**RE: Addendum #2 25-02 Southport Sports Complex**

Please accept this as Addendum No. 2 for the above referenced solicitation.

For clarification purposes, **please see revised and additional drawings:**

**TYPICAL DUGOUT SLAB @ GRADE PLAN**  
 SCALE: 1/4" = 1'-0"

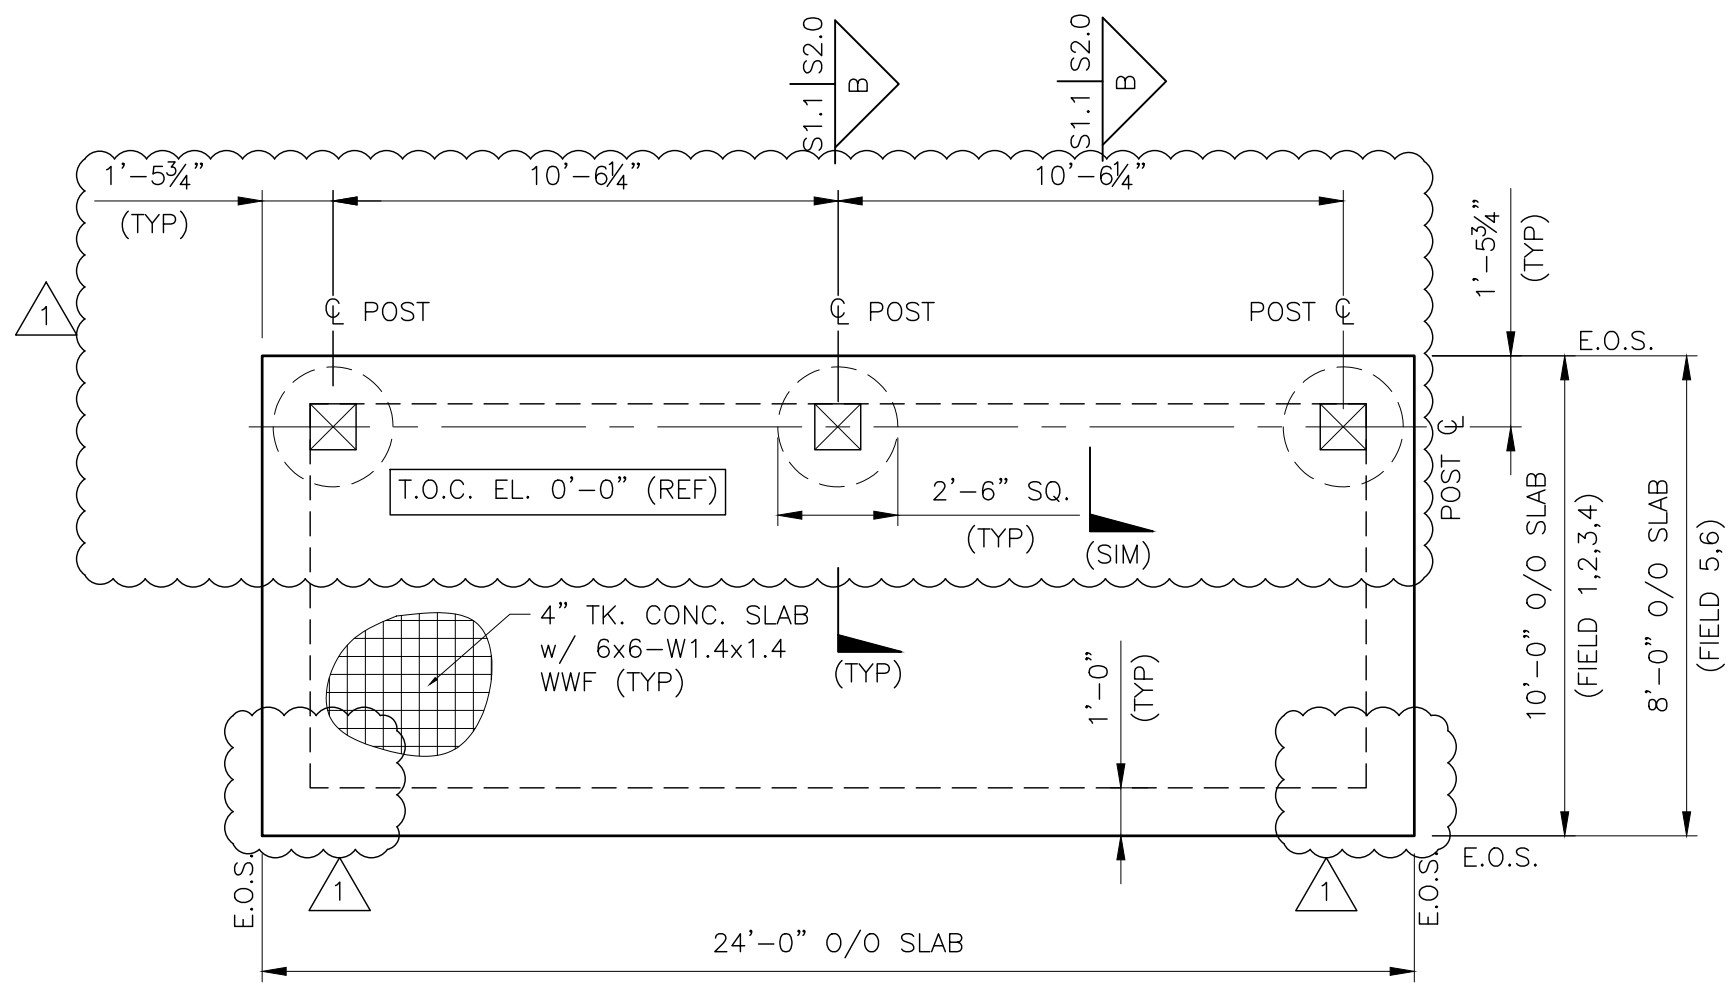
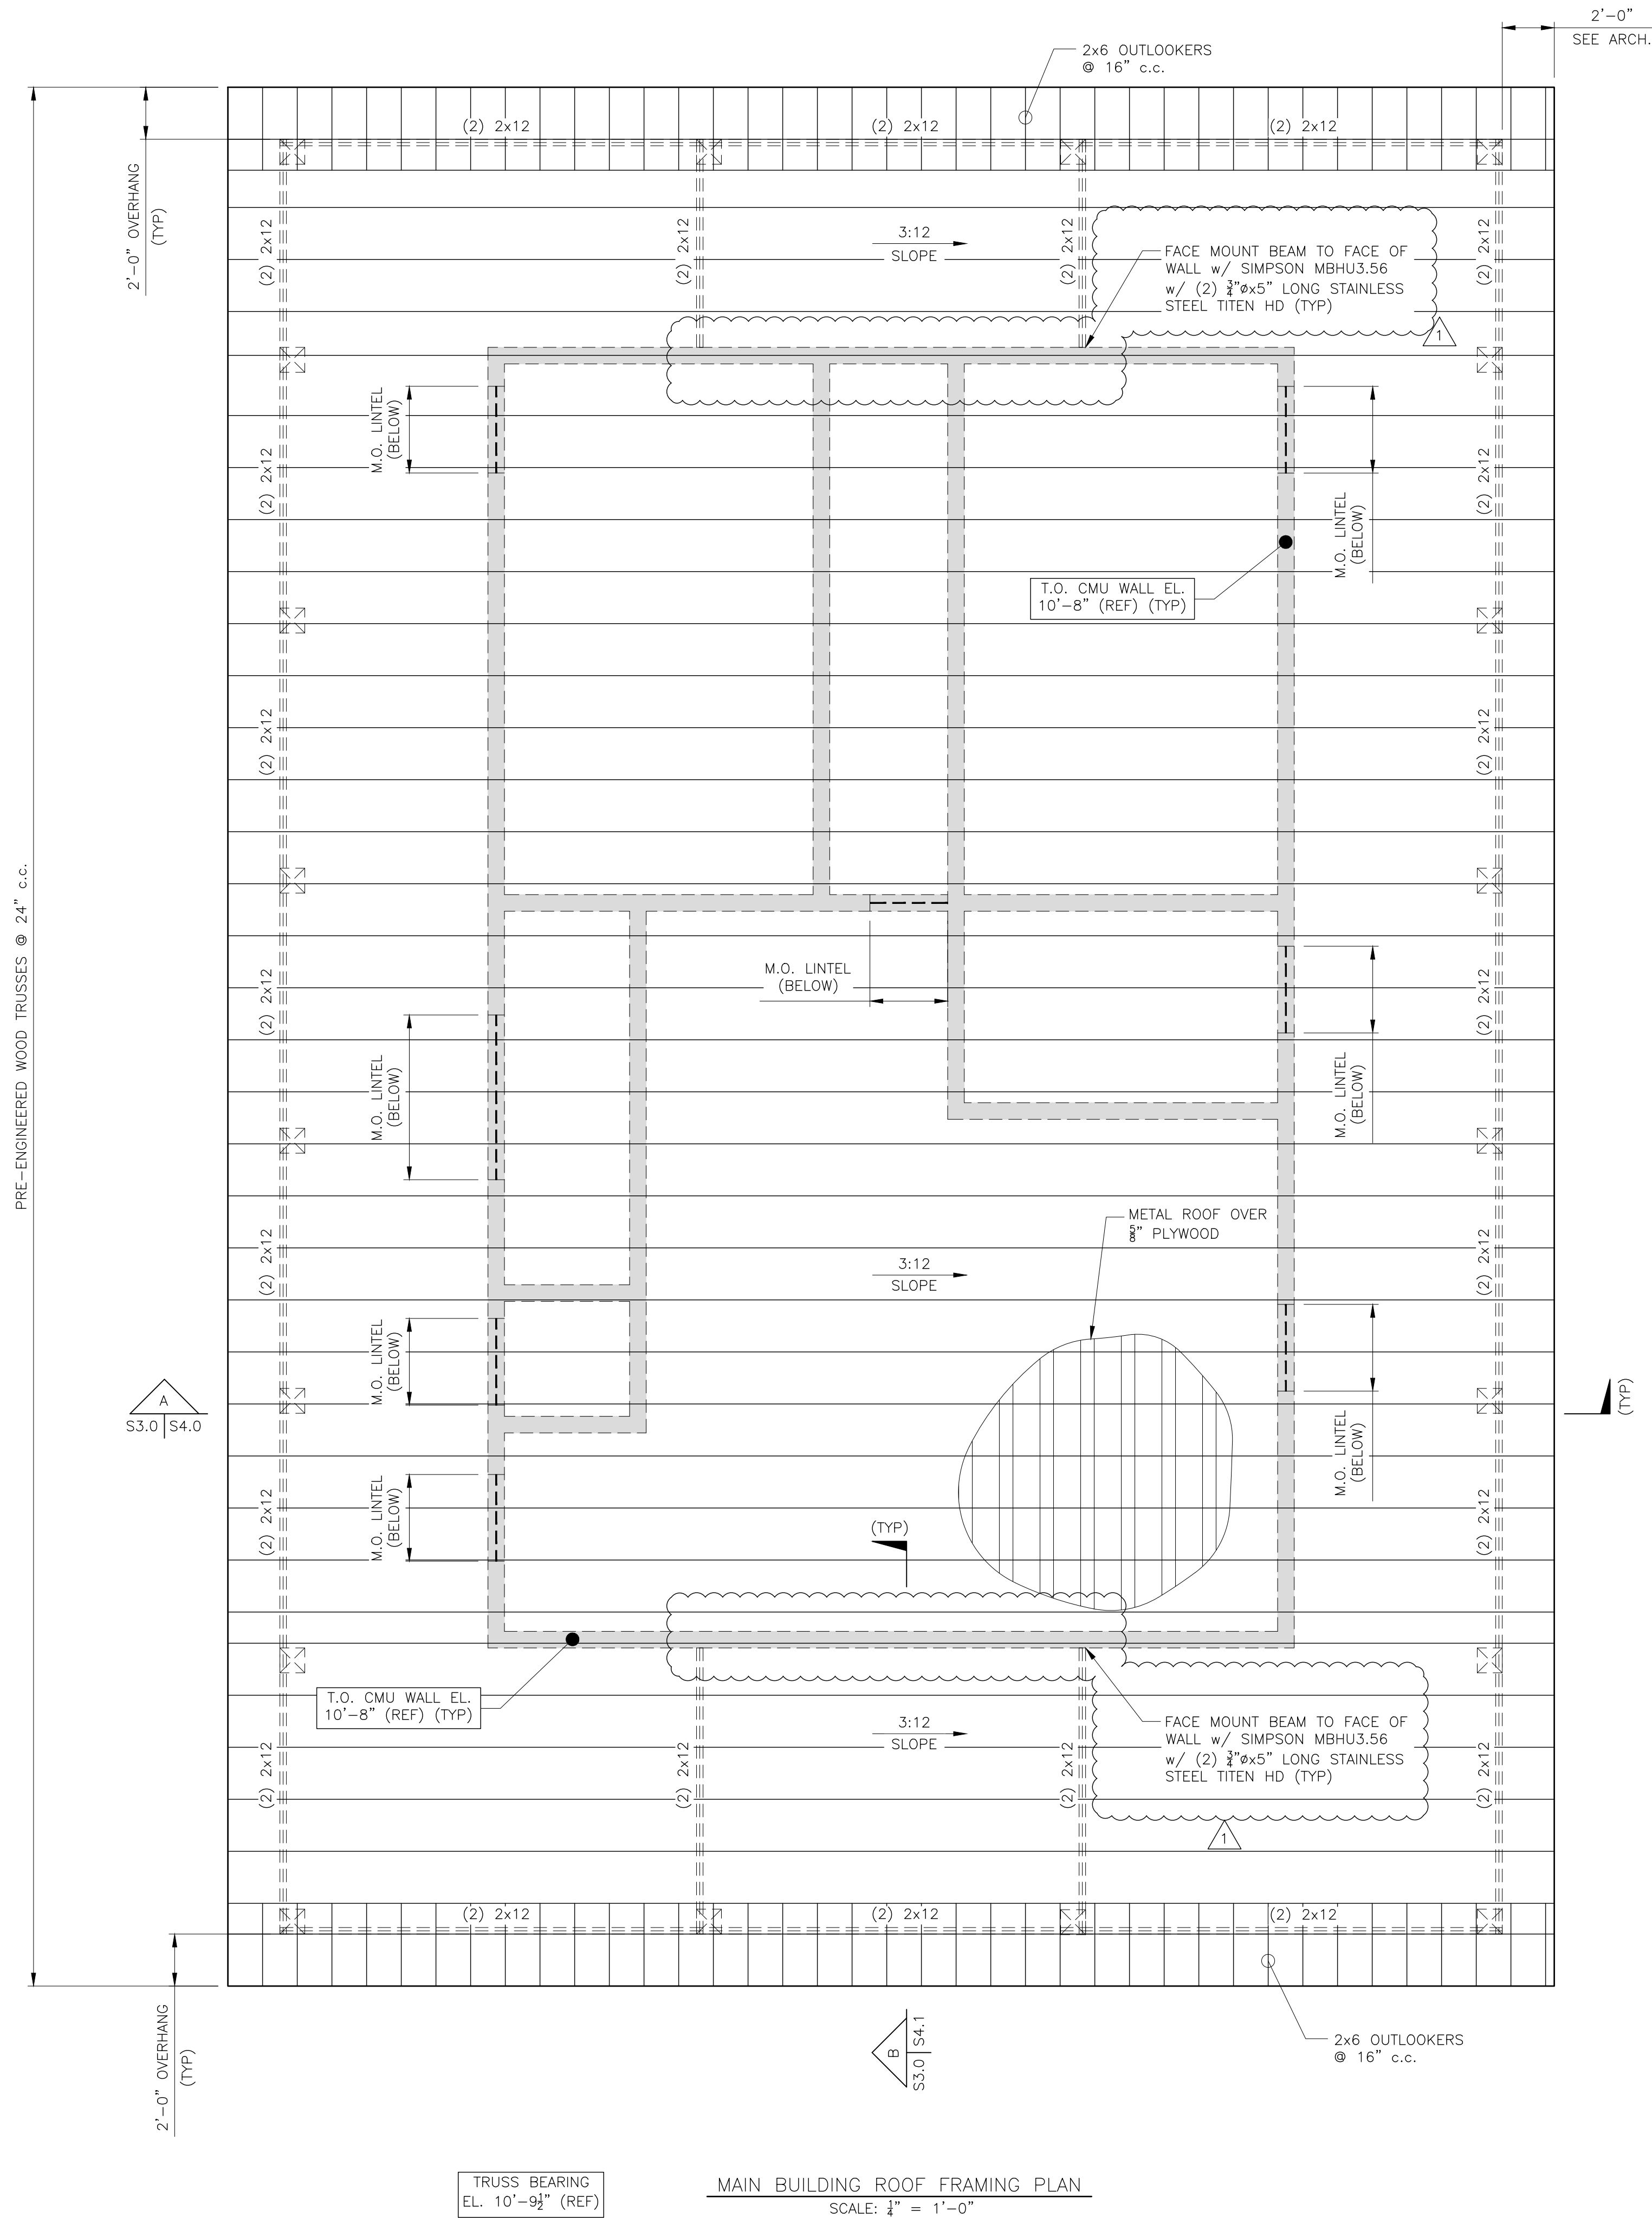
18. Framing detail on S3.1-F calls for 8x8 PT posts on the Dugout but A2.3 and other notes call for 12x12 PT posts. Please advise which is correct. **12x12 PT posts are correct.**

REV.	DR.	CHK.	DATE	DESCRIPTION
0	WS	WS	7/11/2024	ISSUED FOR PERMIT
1	WS	WS	10/15/2024	REVISED POST SIZE FOR DUGOUT
